REPORT ON THE PROPOSED  
"NEUSE FAULT"

Prepared for  
CAROLINA POWER & LIGHT COMPANY

by  
EBASCO SERVICES, INCORPORATED

January 31, 1983

Figure 2. Isopachous map of Cretaceous Unit F (modified from Brown et al., 1972).

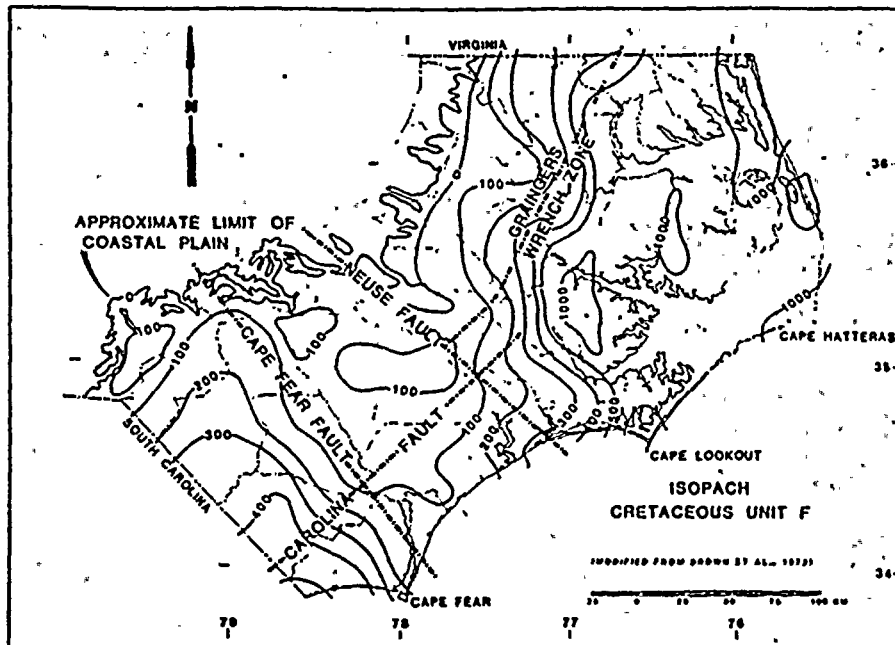
In comparing the figures from both papers, Harris and others (1979b) have apparently mislabeled a contour line on the isopach map of unit F. A contour line north of the "Neuse Fault", which should be labeled 500 m, is labeled 1000 m on the figure of Harris and others (1979b).

Although Cretaceous unit F does thicken north of the proposed Neuse Fault, the Neuse Fault does not coincide with the greatest change in thickness of the unit.
